WCAP-16793-NP, Rev.0 (Non-Proprietary)
Project No. 694

March 2, 2009

OG-09-84

Subject: Pressurized Water Reactor Owners Group
Responses to the NRC Request for Additional Information (RAI) on WCAP-16793-NP, "Evaluation of Long-Term Cooling Considering Particulate, Fibrous and Chemical Debris in the Recirculating Fluid" (PA-SEE-0312)

Figure 2 Comparison of Reactor Vessel Metal Temperature at Top of Fuel; Outside Diameter versus Inside Diameter

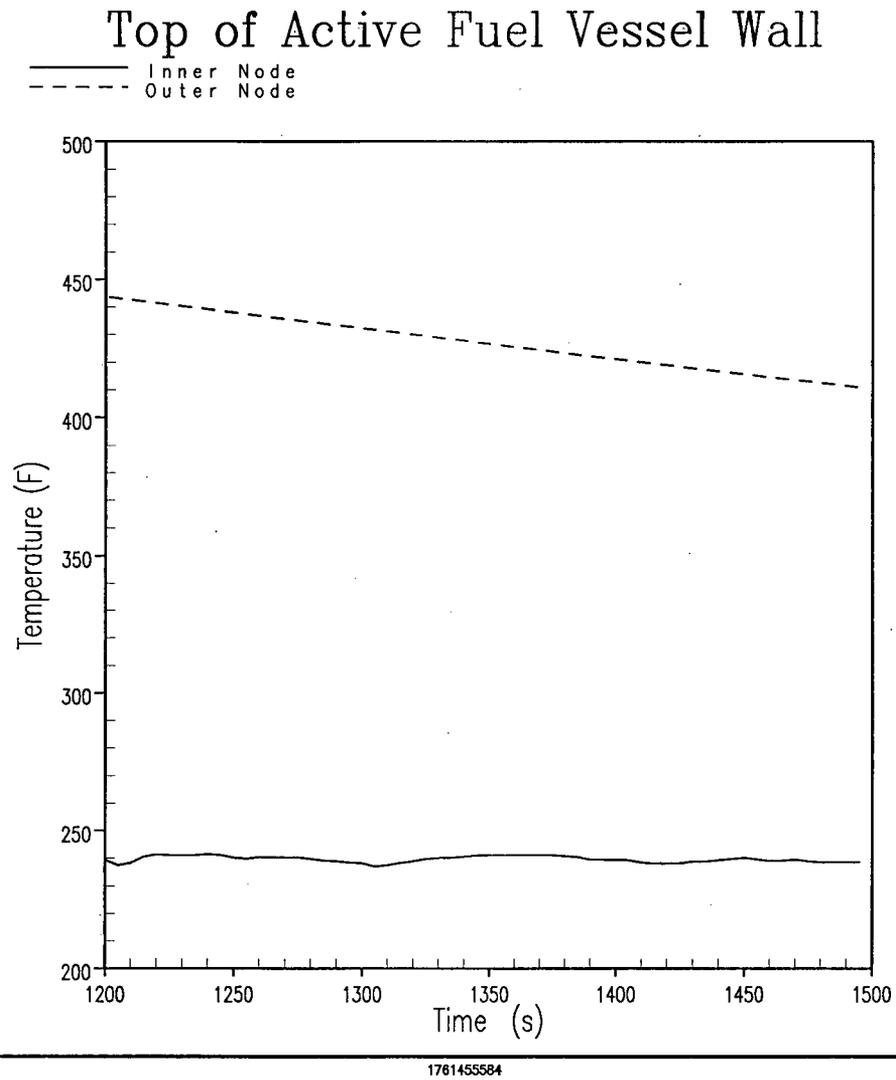
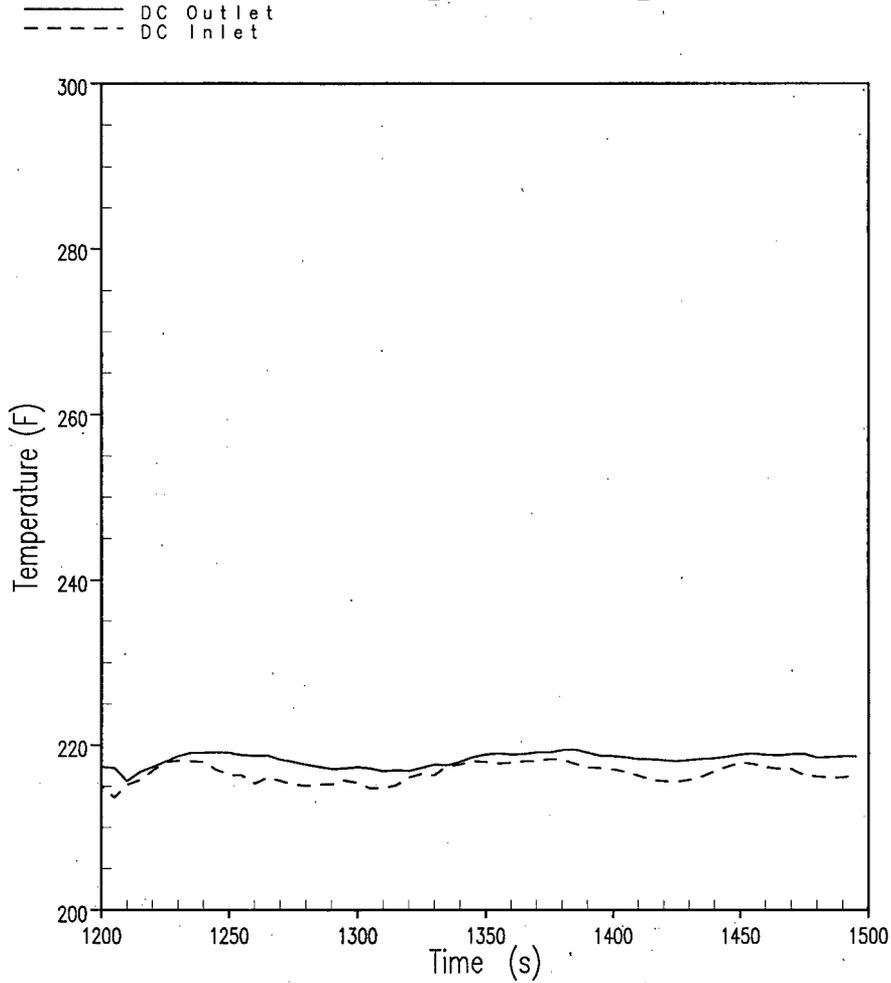
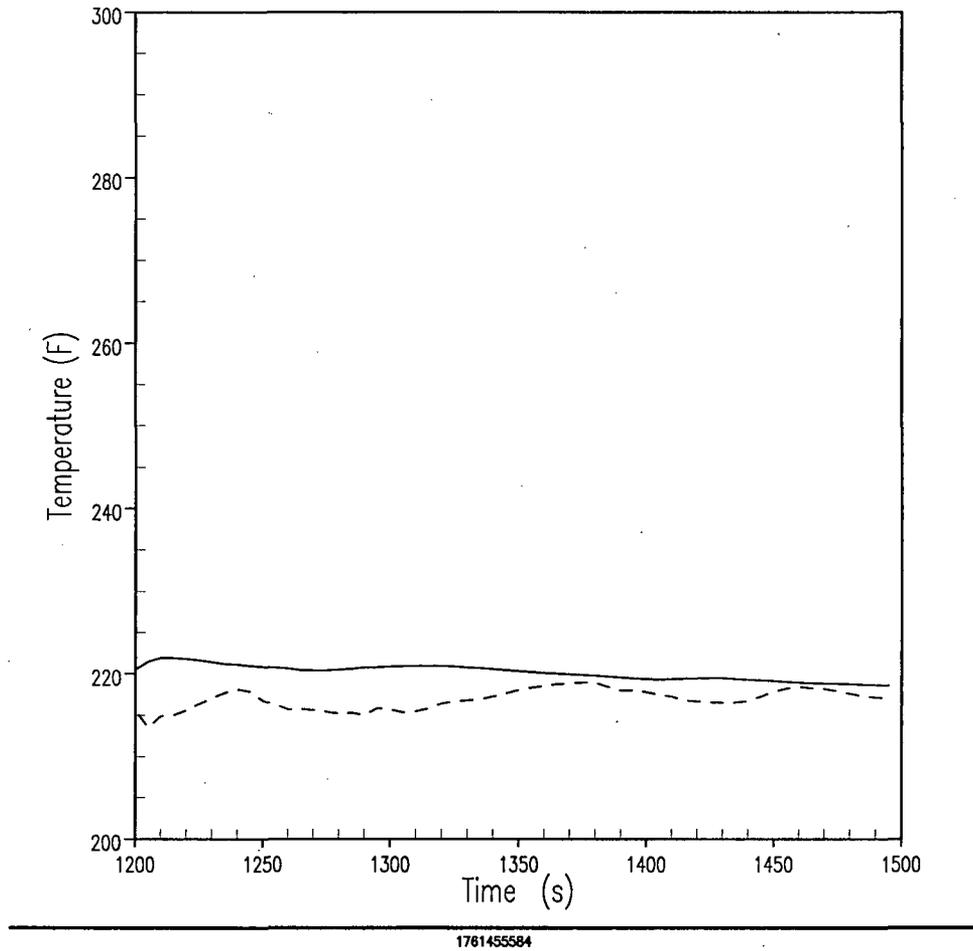
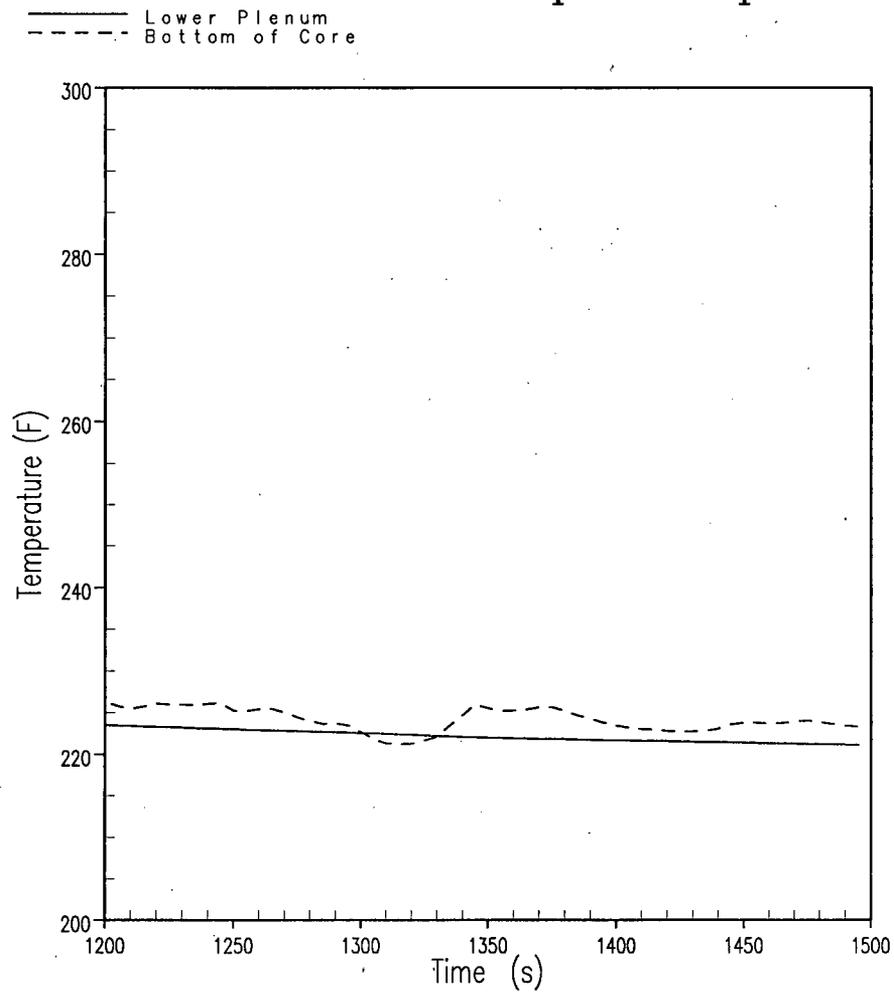
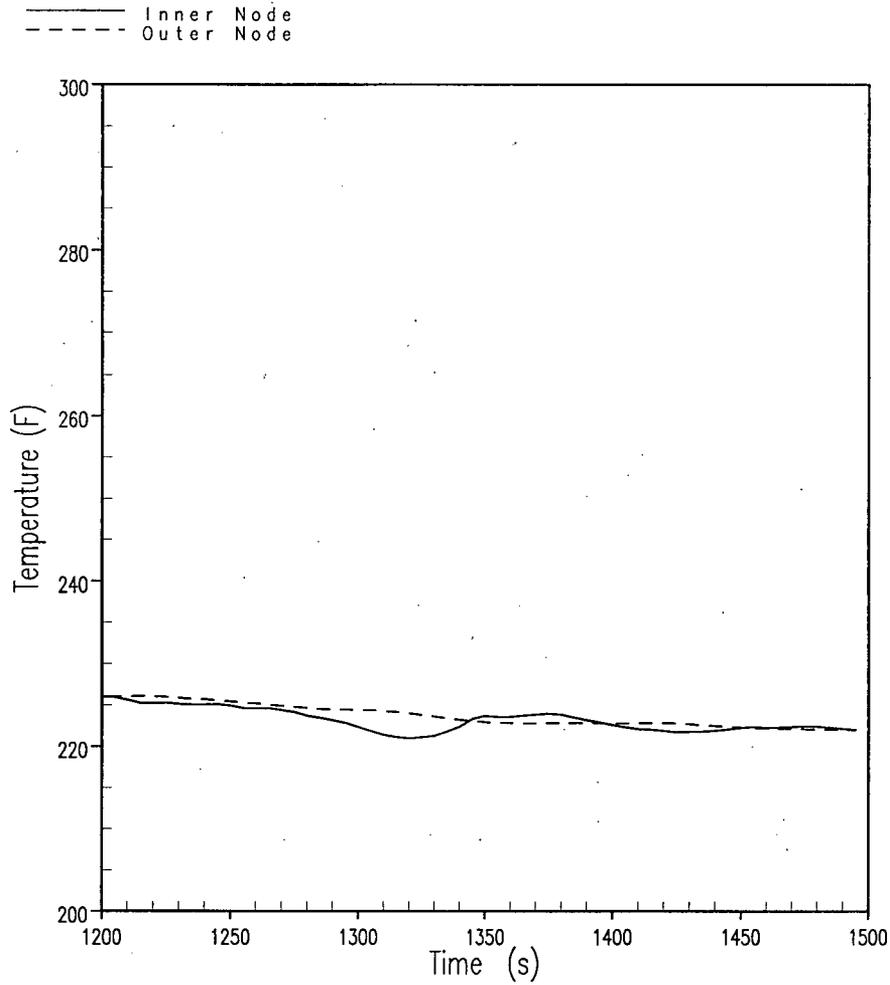
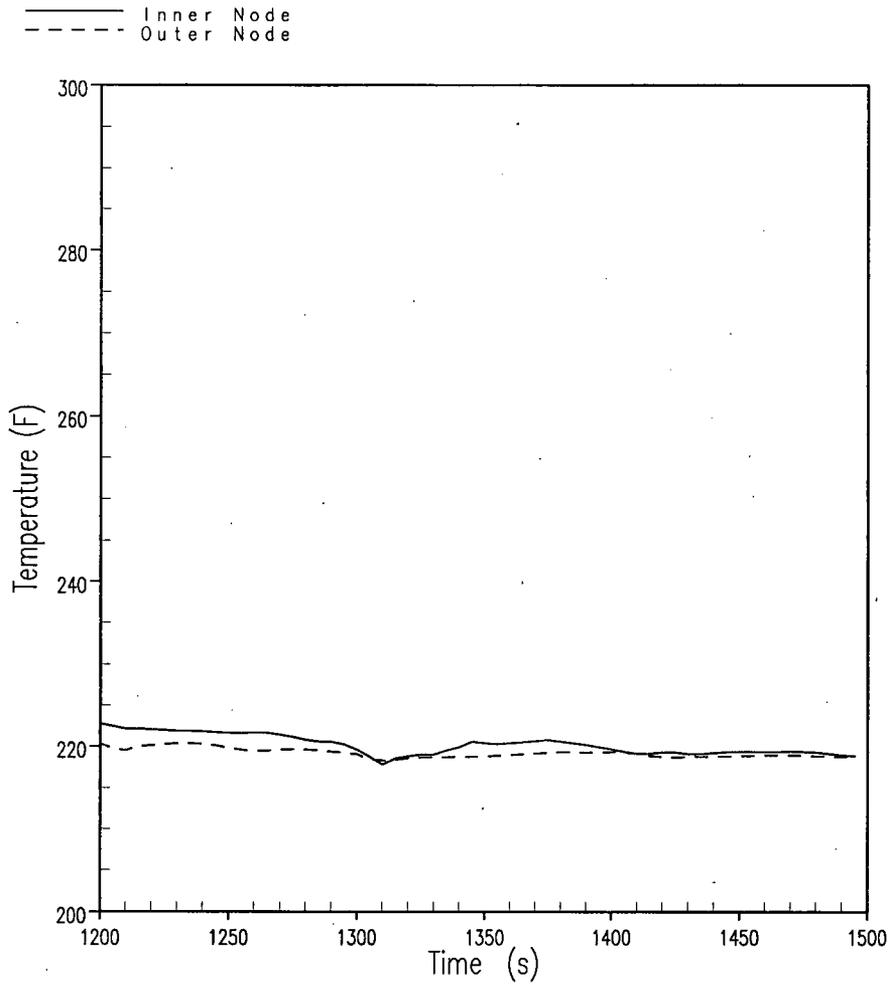
- 8) Following a LOCA, thermal energy stored in the thick reactor vessel shell and the reactor vessel baffle/barrel can influence the coolant temperature at the core inlet. For both a hot leg break and a cold leg break, please provide an estimate of the core inlet temperature as a function of time, starting at the onset of ECCS recirculation and ending when an equilibrium reactor vessel metal temperature has been reached. Please discuss how this temperature would affect:
- the solubility of aluminum-based precipitates,
 - the solubility of calcium-based precipitates and,
 - the potential for chemical precipitates to form in the vessel as a result of these phenomena.

Figure 1, Comparison of Reactor Vessel Metal Temperature at Bottom of Fuel; Outside Diameter versus Inside Diameter, and Figure 2, Comparison of Reactor Vessel Metal Temperature at Top of Fuel; Outside Diameter versus Inside Diameter, are time history plots of the temperature of the inner and outer RV metal nodes of the WCOBRA/TRAC calculations for a postulated cold-leg break. From Figures 1 and 2, it is noted that the temperature of the inner RV metal node at the top and bottom of the core is relatively unchanged over the 300 seconds following switchover from BWST/RWS injection to recirculation from the reactor containment building sump. Over this same time period, the outer RV node is predicted to drop by about 30°F. These figures demonstrate that the heat transfer process is conduction limited.

Figure 3, Comparison of Fluid Temperature at Top and Bottom of Downcomer, shows that there no more than about 5°F temperature gain in the coolant as it passes from the top to the bottom of the downcomer. Likewise, Figure 4, Comparison of Fluid Temperature at Top and Bottom of Baffle, shows a similar behavior. It is noted that the initial 10°F temperature difference diminishes to about a 5°F temperature difference within about 150 seconds of switchover from BWST/RWST injection to recirculation from the reactor containment building sump. Figure 5, Comparison of Fluid Temperature in Lower Plenum to Core Inlet, shows that the coolant at the core entrance is calculated to be generally slightly warmer but within about 5°F of the coolant in the RV lower plenum. Figures 6 and 7, Comparison of Fluid Temperature Between Core Inlet and Inside Baffle, and Comparison of Fluid Temperature Between Core Outlet and Inside Baffle, respectively, shows the calculated fluid temperatures at the core inlet and core outlet to be within less than about 5°F of each other throughout the calculation time period. More importantly, over
